# Proposed changes to London Luton Airport Arrivals

## CAP1616 Stage 4 Step 4A(i) Consultation Response Document

**Figure 9 The consulted-upon hold in context with airspace constraints (must be within unshaded area)**

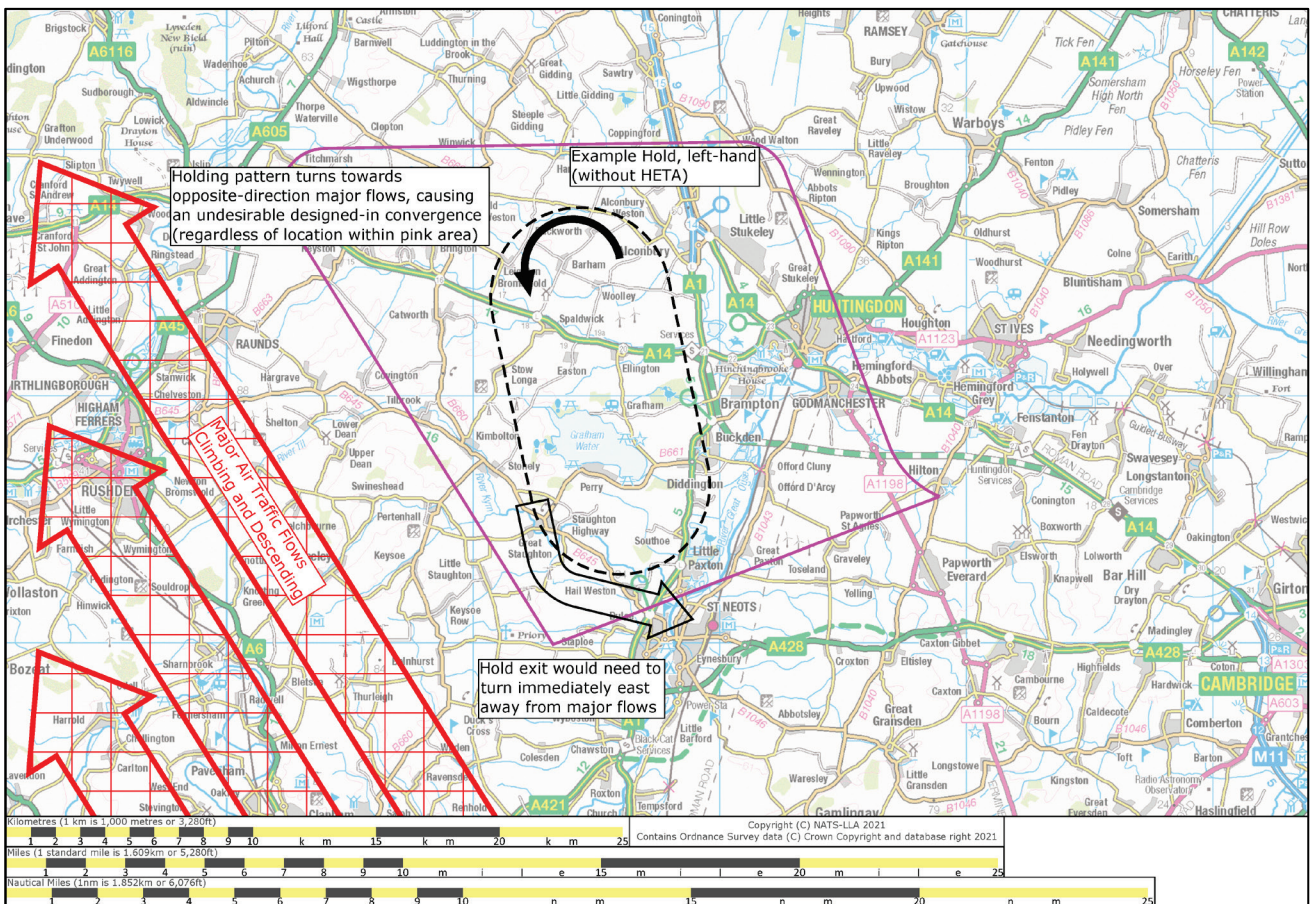
- 6.15. From these paragraphs and maps you can understand why we needed to place the hold in this area.
- 6.16. Design suggestions and recommendations placing the holding pattern outside the unshaded area cannot be accommodated, for the reasons above.
- 6.17. However, localised adjustments are possible within the unshaded area.

**Figure 13 Hold Altitude Constraint and Potential Design Opportunity**

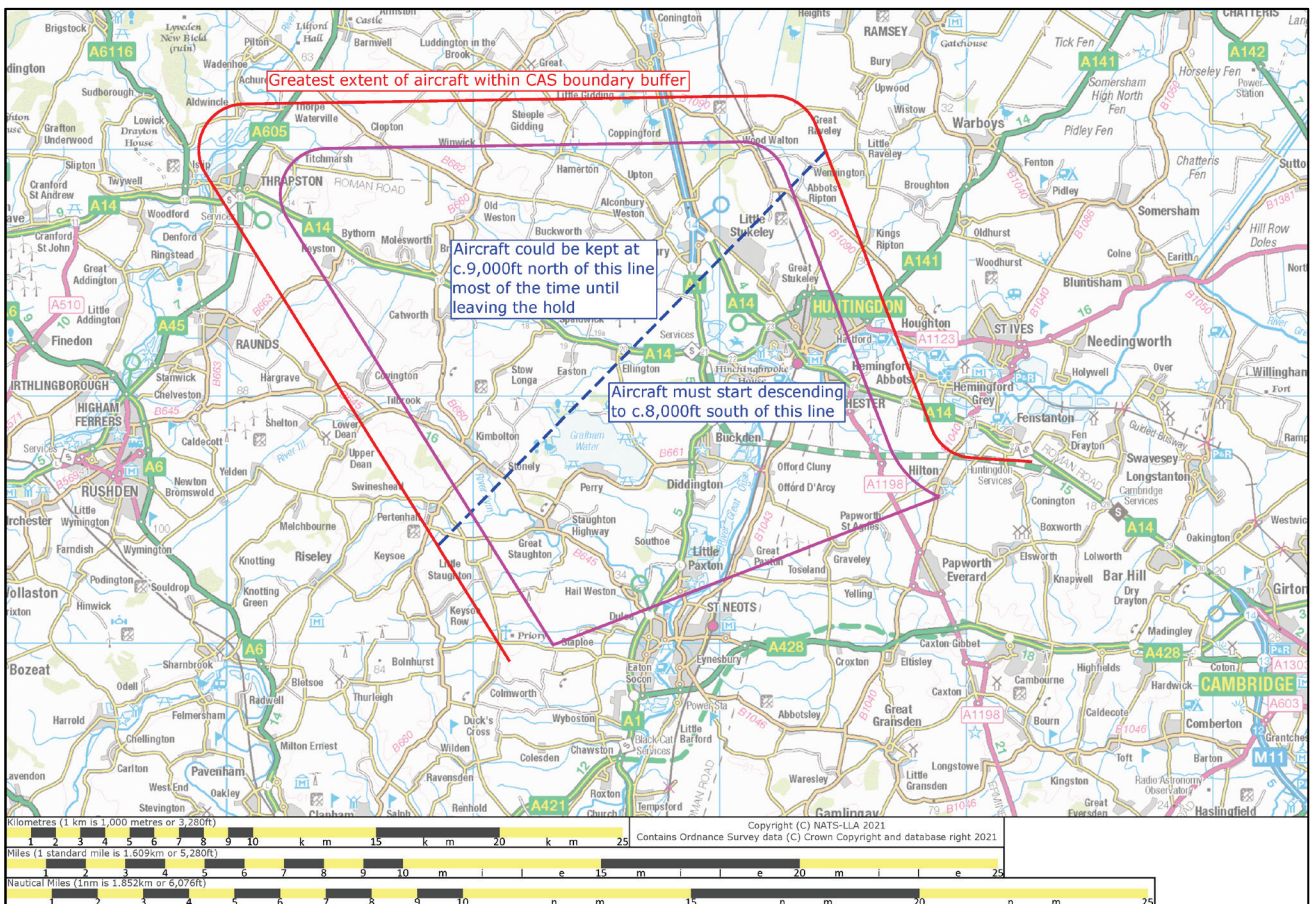
- 6.24. Figure 13 illustrates the greatest extent an aircraft could be expected to fly, if being vectored under full tactical control (red line), and shows the holding region in solid pink (representing the unshaded area from Figure 9). Both these constrained regions were described earlier in this document. The blue dashed line illustrates a potential design opportunity.

- 6.24.2. This design opportunity is limited because ATCOs must have maximum flexibility for contingency purposes. The hold would need to be immediately available at c.8,000ft 24 hours per day, should there be an unplanned runway closure or similar event<sup>3</sup>. CAS in the region could not have a higher base or that contingency holding altitude would be lost.

- 6.25. From this paragraph and Figure 13 you can understand the altitude constraint and design opportunity we have identified.
- 6.26. Design suggestions and recommendations to significantly raise the holding pattern, or to absolutely guarantee a minimum of c.9,000ft in the region, cannot be accommodated, for the reasons above.

**Figure 14 Route Altitude Constraint and Potential Design Opportunity**

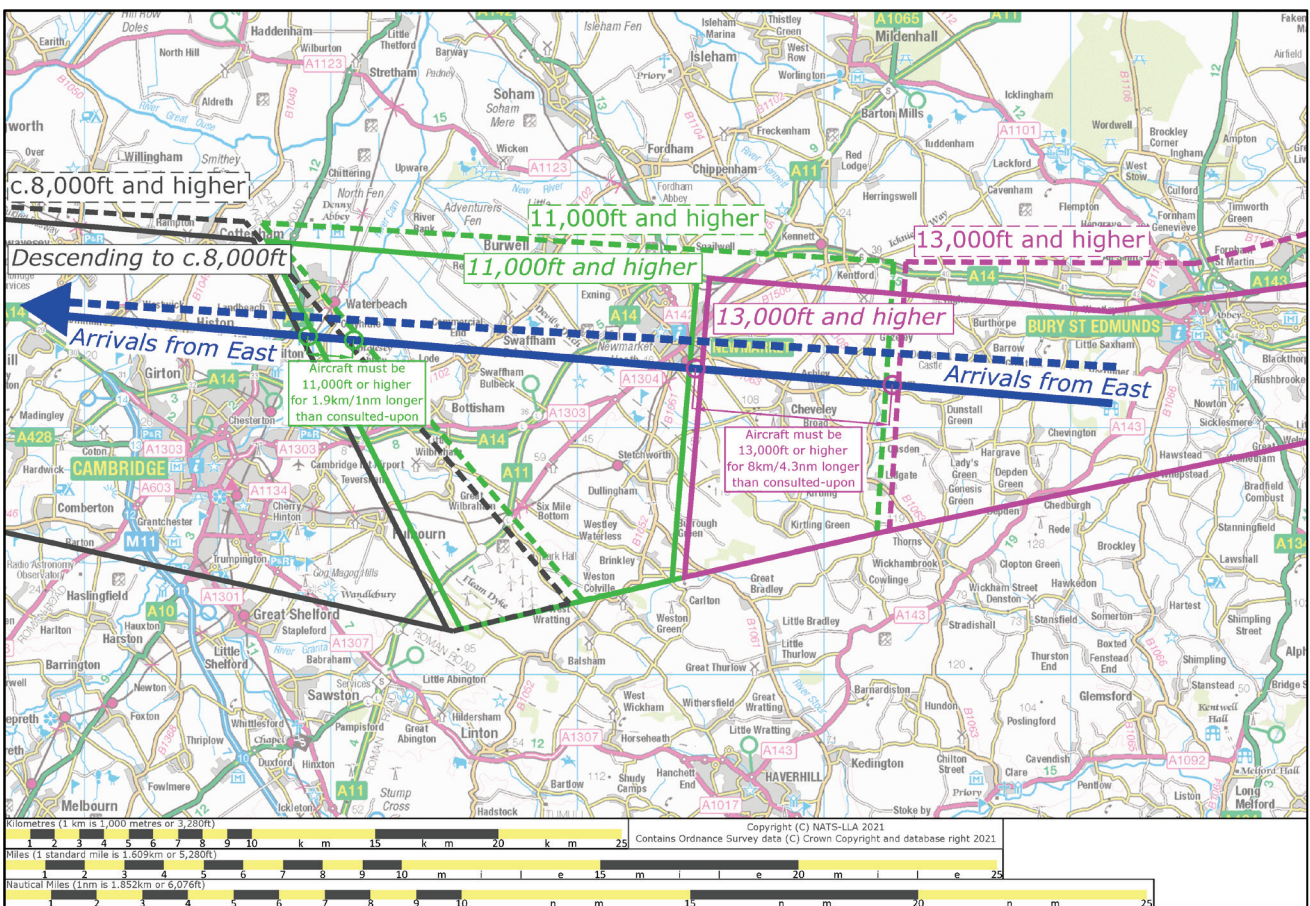
- 6.29. Figure 14 illustrates the consulted-upon route (blue dashed line) and the predicted lowest possible altitudes for arrivals from the east (pink, green and dark-grey dashed lines).
  - 6.29.1. We have identified an opportunity to adapt the descent profile of these arrivals, keeping aircraft higher for longer. Higher aircraft generally burn less fuel, and less noise is observed by people living under the route.
  - 6.29.2. We have calculated that moving the route slightly further south (solid blue line), and refining the planned descent profile, controlled airspace (CAS) bases could be slightly modified.

- 6.29.4. The CAS base change from 13,000ft to 11,000ft could be safely moved west c.8km. This means that aircraft could not descend below 13,000ft until the new CAS base-change position (solid pink line perpendicular to the blue route).

- 6.29.6. The CAS base change from 11,000ft to c.8,000ft could be safely moved west c.1.9km. This means that aircraft could not leave 11,000ft to start descending to c.8,000ft until the new CAS base-change position (solid green line at an angle to the blue route).

- 6.30. From this paragraph and map you can understand the design opportunity we have identified.
- 6.31. Design suggestions and recommendations to keep routes significantly higher than this, and/or for significantly longer, cannot be accommodated.
- 6.32. However, an adjustment of the arrival route from the east, and its CAS bases, is possible to keep aircraft higher for longer as described above.
- 6.33. For the avoidance of doubt, aircraft arriving at LLA could not be lower than as described in Figure 14.

Figure 15 Consulted-upon holding region (above), Final Design holding region (below)

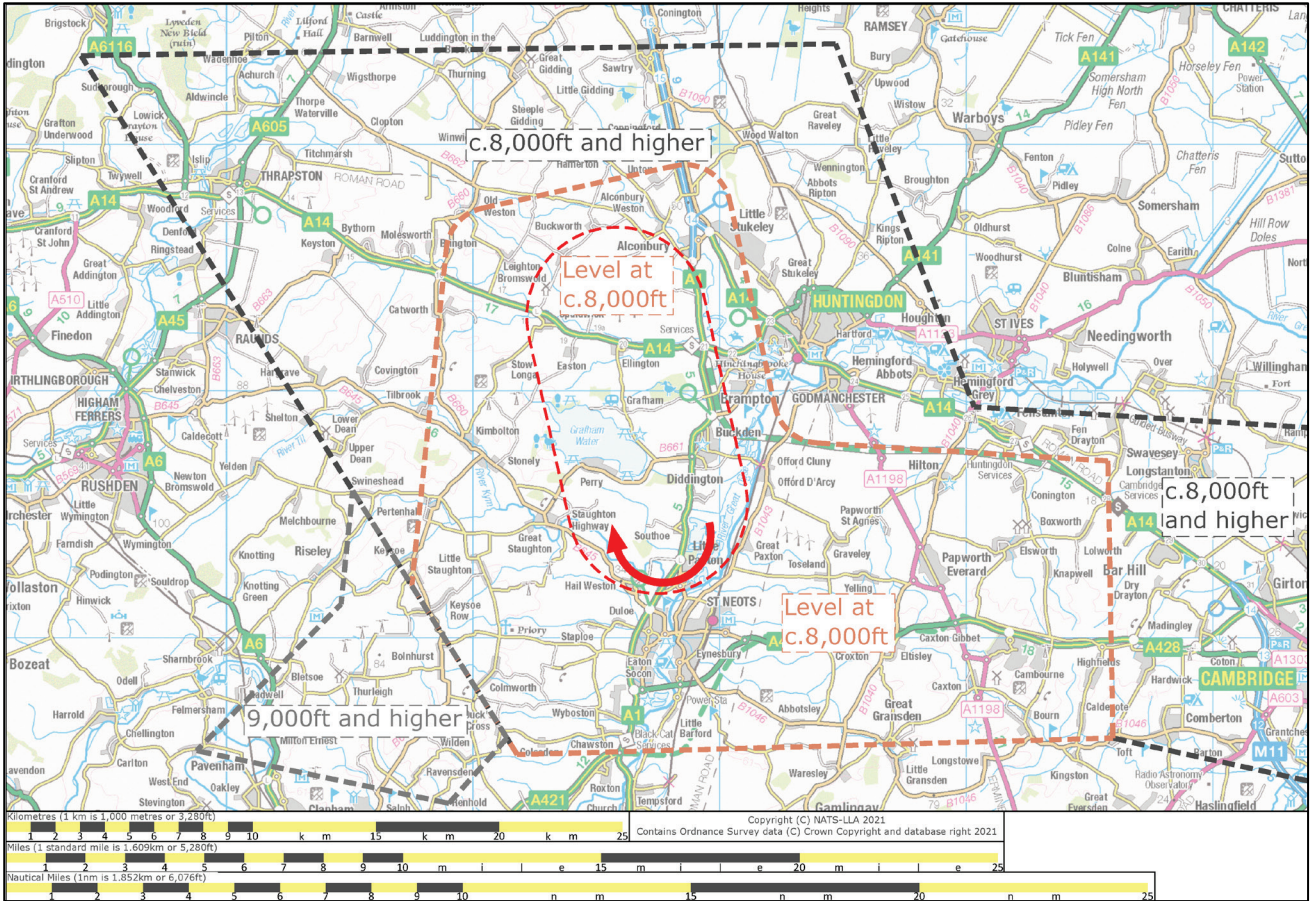
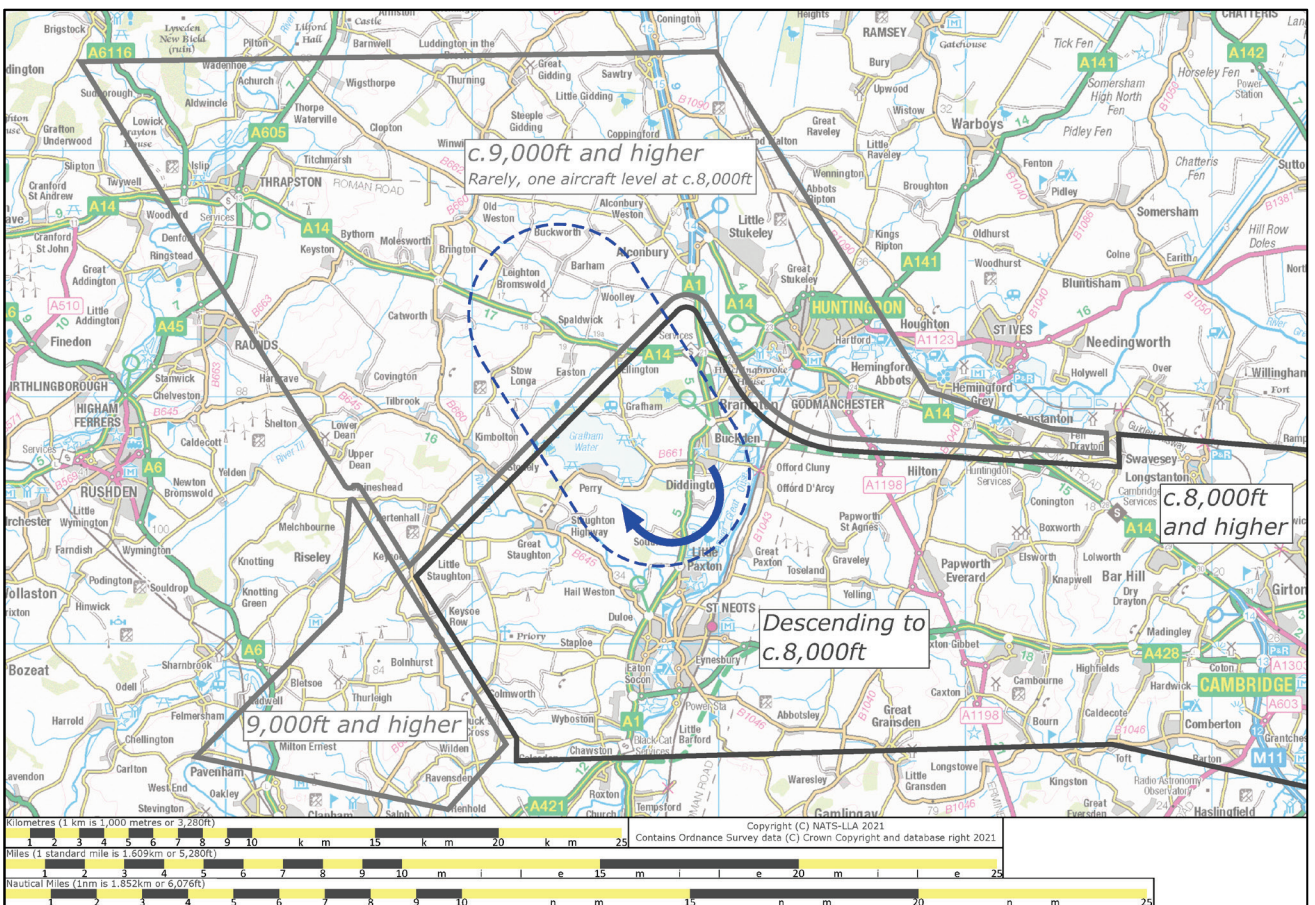
There is scope to minimise the impact on the two specific urban locations in **1.01** and **1.02** by adjusting the hold within the constraints of the pink region (as illustrated in Figure 7 on p.13).

The constraints explained earlier in the document, combined with the mutual incompatibilities of some recommendations against others, mean these cannot be acted upon.

6.41. Change log: Comparison of the consulted-upon holding region, and the Final Design holding region

Figure 16 Final Design: Option 1 arrivals to Runway 07 (above) and Runway 25 (below), reproduced from the Consultation Document (note that the illustrated hold has moved, see Section 6)

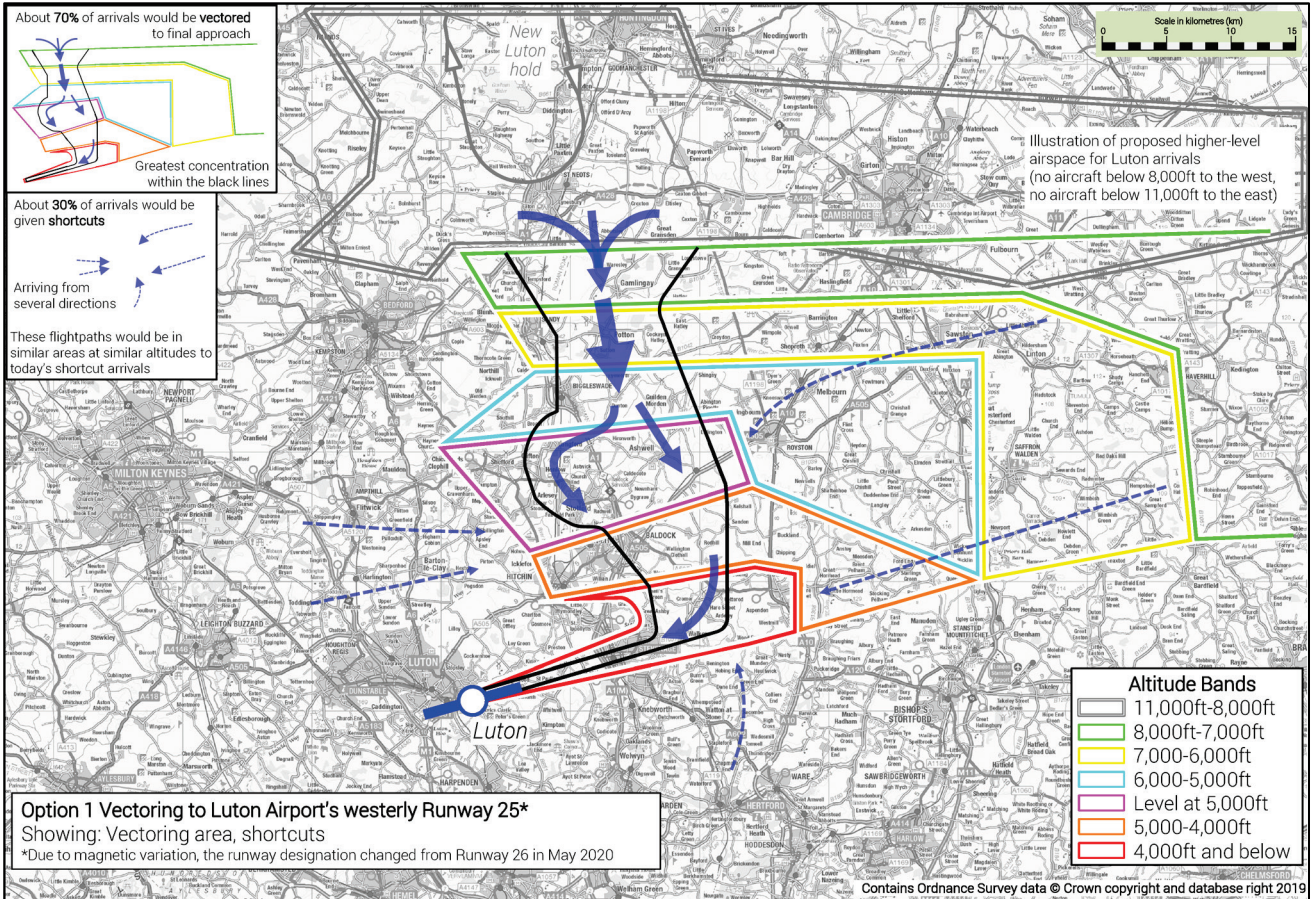
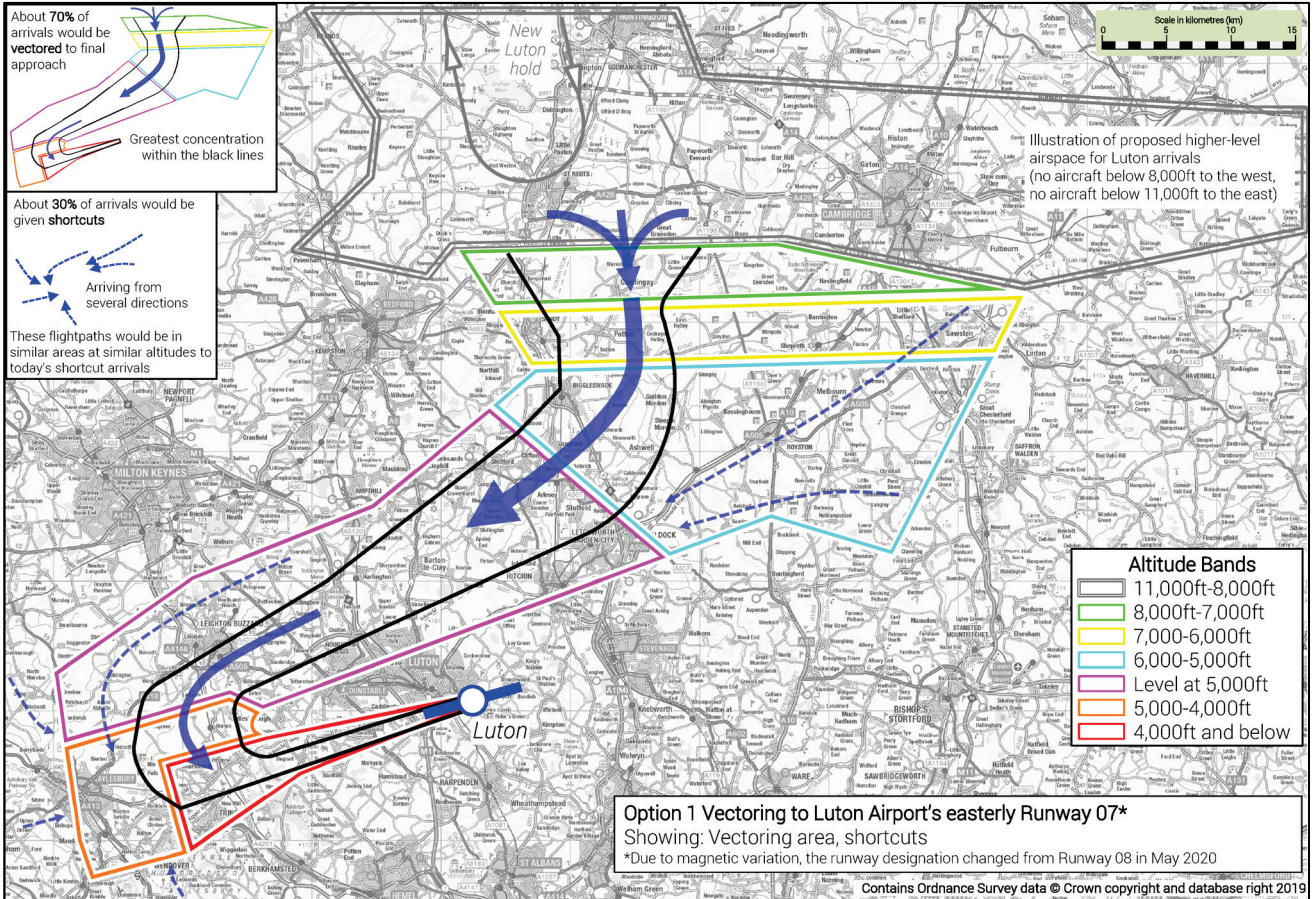
- We cannot act on 2.02 because it recommends changes to the PBN routes, and Option 2 is not progressing.
  - We cannot act on 2.04 because both consulted-upon Options already keep aircraft slightly higher, above 5,000ft, as high as possible against other traffic flows (adjacent unchanging Heathrow, London City and Stansted departures). Continuous descents are only possible from 5,000ft and below regardless of the operational concept.

- We cannot act on 2.05 because Option 1 minimises changes to flightpaths from 5,000ft to the runway. For example, requests to change flightpaths in the Stevenage area cannot be acted upon because of the fixed geographical relationship between the town and LLA's final approach.

- We cannot act on 2.06 because Biggleswade is between the holding region and the runway and we could not guarantee to avoid overflight. However, the changes made in Section 6, combined with this Section's decision to progress Option 1, means that flightpaths are more likely to be dispersed across the black-lined areas between 8,000ft-5,000ft in Figure 15 than down the centre.

- We cannot act on 2.08 because Gamlingay and Potton are both between the holding region and the runway and we could not guarantee to avoid overflight. However, the changes made in Section 6, combined with this Section's decision to progress Option 1, means that flightpaths are more likely to be dispersed across the black-lined areas between 8,000ft-5,000ft in Figure 15 than down the centre.

- 7.19. Change log: The Final Design below 8,000ft
- 7.19.1. We have acted upon Recommendations **2.01** and **2.03**, the effect of which is to progress Option 1 Vectoring below 8,000ft. There are no changes to the vectoring area design below 8,000ft.

Figure 17 Shortening the proposed route structure (with illustration of Stansted constraints)

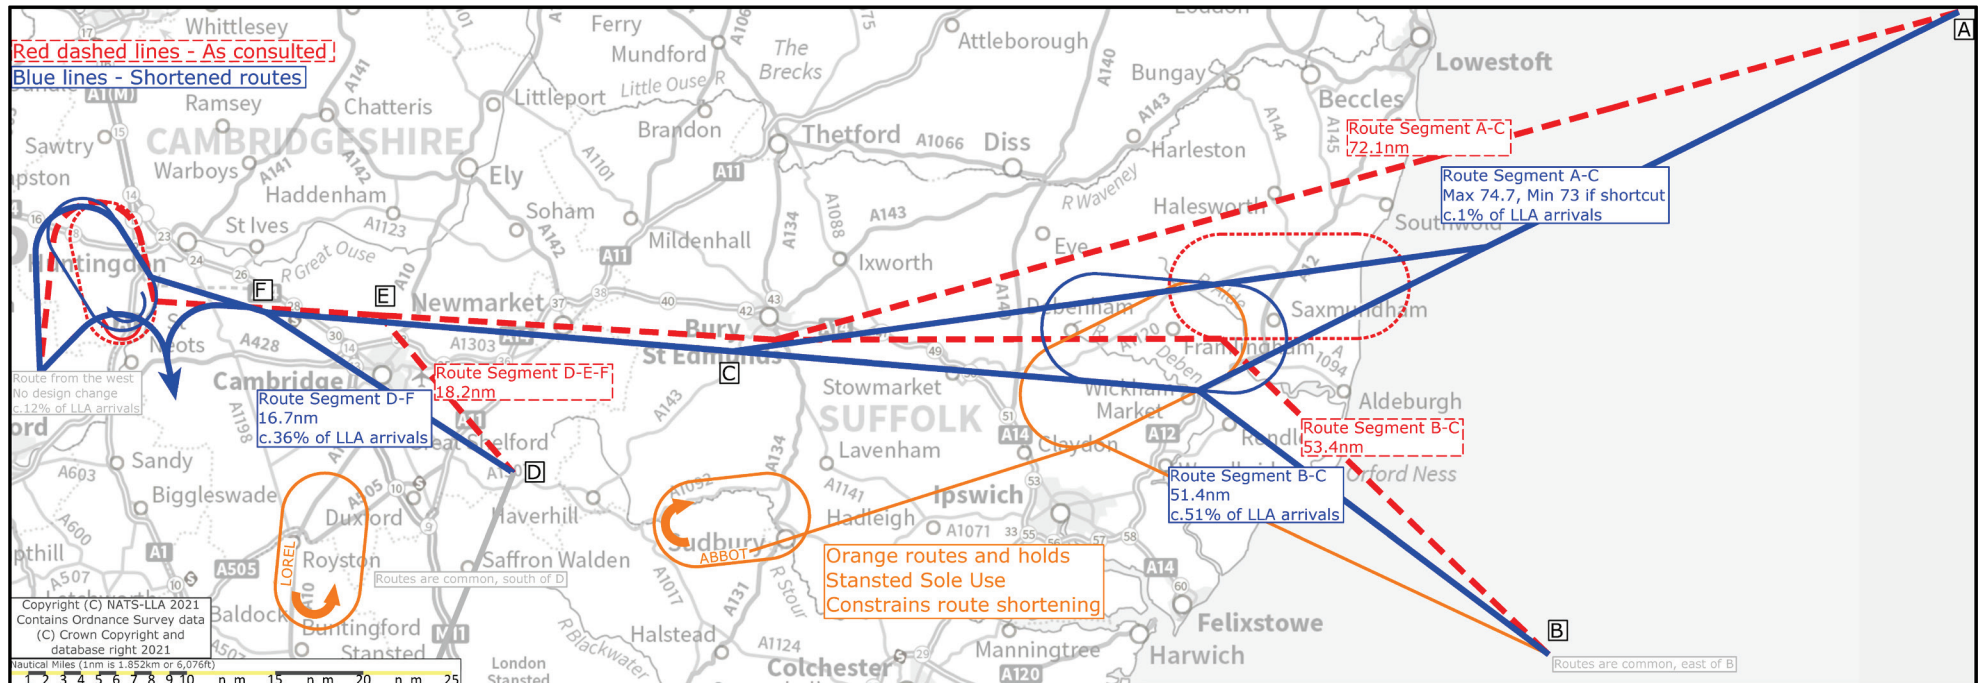
- 8.6. The route segment from C to F is equivalent length-wise, but in Section 6's Figure 14 on page 19 and paragraph 6.42 on p.23 we explain how we changed the design to keep aircraft higher for longer as per Recommendation **1.24**. This meant moving the route slightly further south and raising CAS bases which reduces the impact on other airspace users such as USAFE.

- 8.7. The blue solid lines illustrate the shortening of routes between these common points, given the constraints of the orange Stansted routes.
- 8.8. Change log:

- 8.8.1. Blue Route Segment A-C would be slightly longer than Red (between 0.9nm-2.7nm depending on whether the shortcut was available due to adjacent traffic). This route is only used by c.1% of LLA arrivals, and has been modified to minimise the CAS that needs to be implemented to contain the routes, reducing impacts on other airspace users such as USAFE (see Section 9 Action 4 for details).
